RIGGING ADVISORY CIRCULAR

RAC No. 817 Rev. A

SUBJECT: MS 22040-1 INSPECTION

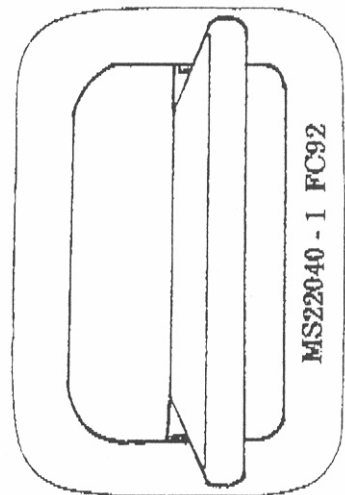
IDENTIFICATION: Adjuster part no. MS 22040-1 manufactured by United States Forgecraft identified with a date of manufacture Fc 92.

BACKGROUND: The Relative Workshop product service bulletin 062193 dated 21 June 93 has identified incorrectly manufactured MS-22040-1 adjusters on Vector container systems manufactured between 22 April 93 and 10 June 93.

RELATIVE WORKSHOP POLICY: At the next scheduled reserve repack, inspect Vector systems with serial numbers between 21732 and 28674 which have MS 22040 adjusters fitted, against the following diagrams. If hardware is correct, note bulletin compliance on data card, if hardware is incorrect, notify Relative Workshop. Check for this hardware on:
leg straps (*tandem & sport harness*) and,
chest straps (*tandem and tandem passenger harness*).

Drawing C

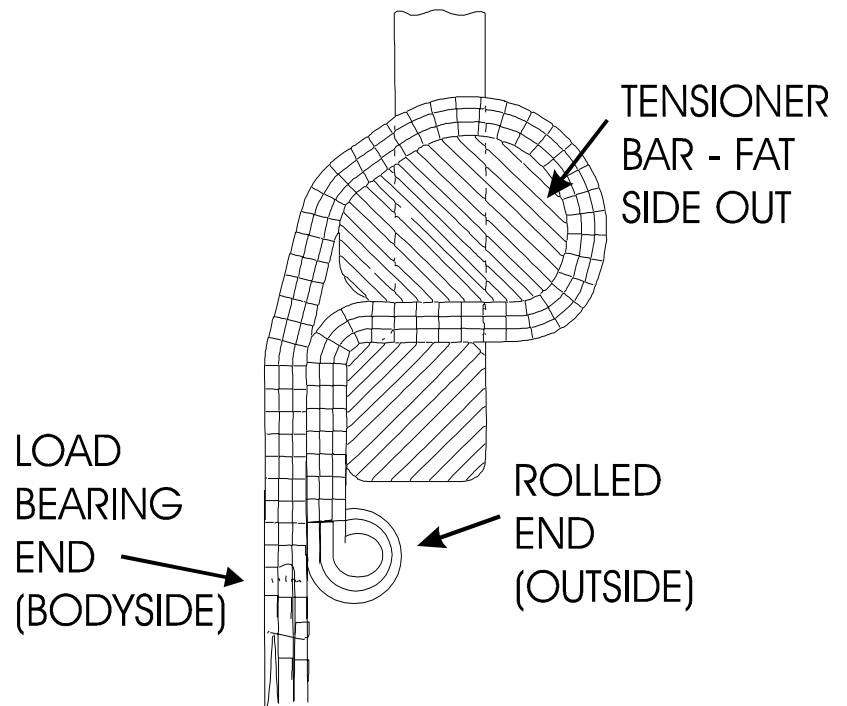
APF POLICY: At the next scheduled reserve inspection, check ALL parachute systems which incorporate MS22040-1 adjusters and other hardware using the same sliding tensioner bar in their construction. If hardware is incorrect, notify the manufacturer of the defect and have a Rigger or the manufacturer rectify the equipment.
To aid in the identification of incorrectly assembled hardware refer to Drawing C following.
